ITEM: Inwood 3rd Addition Final Plat and Final Planned Unit Development

SUBMITTED BY: Stephen Wensman, Planning Director

SUMMARY AND ACTION REQUESTED:

An engineering review has been completed for the Inwood 3rd Addition Construction Plans consisting of the following documentation prepared by Carlson McCain:

L3 OF 4

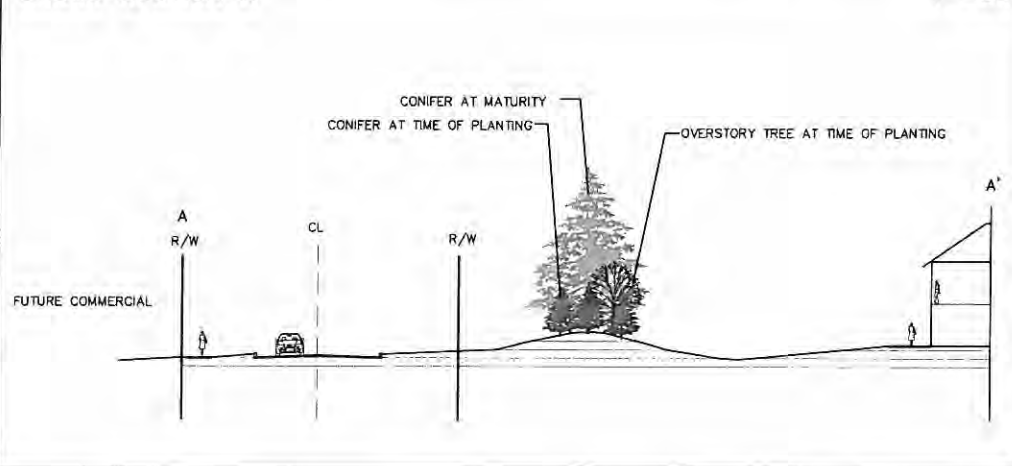
7. Provide a design section of infiltration basin details. I created a quick hand sketch and attached for some ideas / notes of what we discussed at our sit down meeting. Once this is created please update landscape plans notes to be consistent with new graphic. The plans most recently submitted specify Geogrid which is a structural fabric typically utilized for structural reinforcement in a retaining wall system. We discussed utilizing Geotextile Fabric. Please specify an exact product specification as part of the detail... if you would like some suggestions we are happy to redline detail once it is resubmitted and point you to an acceptable product line for this application so you can further your research selection with your client and make a final selection.

10. Add this additional sentence to note #4 under landscape notes on L2 of L4 plans a "Please provide written acknowledgement of this to the City for written City approval prior to planting operations".
11. Provide updated set of grading plans for our review of soils preparation, seeding and drainage details per our recommendations at our last sit down meeting where modifications to drainage sections/details were suggested and discussed. Also, on the landscape plans note for the contractors what the expectation for tree, shrub, perennial and sod planting bed preparation is to be in compliance with project requirements and City specifications/requirements.
12. Provide written acknowledgment from the watershed district that they are aware and approve of the currently proposed non-vegetated infiltration basin designs with the adjusted revisions to the detail sections as discussed.
